SERVICE LETTER

No flight operations permitted with maintenance equipment installed on ROTAX® Engine Type 912 and 914 (Series)

ATA System: 73-10-00 Intake Manifold

Fig. 2

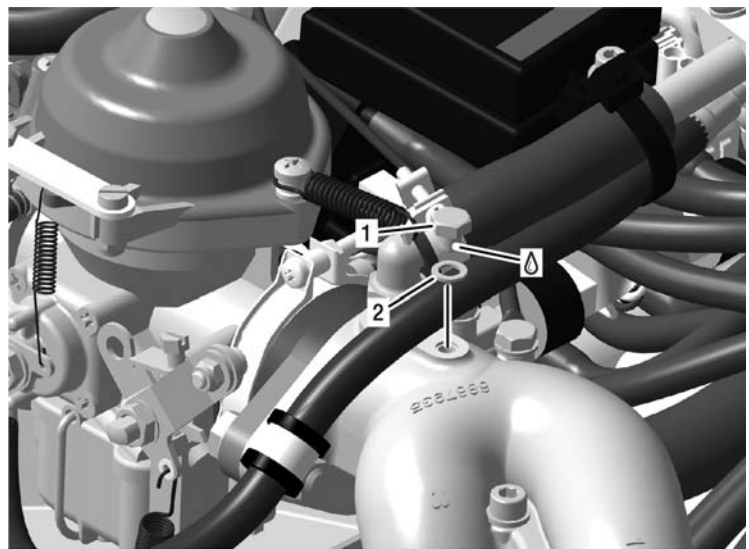
Permanently attached components of special equipment like intake manifold fittings for connecting carburetor balance tool/gauges are not approved by the engine manufacturer for any kind of operation and may e.g. cause induction leaks leading to an excessively lean fuel/air mixture, rough engine running, potential power loss and engine damage.

Example of third-party carburetor balance kit intake manifold fittings.

- Remove all carburetor balancing fittings from the engine before flight
- Fit original ROTAX® Hex. screw M6x6 part number 641071 with gasket A6x10 part number 230415 and LOCTITE 243. See current Illustrated Parts Catalog (IPC) and Maintenance Manual Heavy (MMH).

1 Hex. screw M6x6
2 Gasket A6x10

Hex. screw M6x6 with
LOCTITE 243
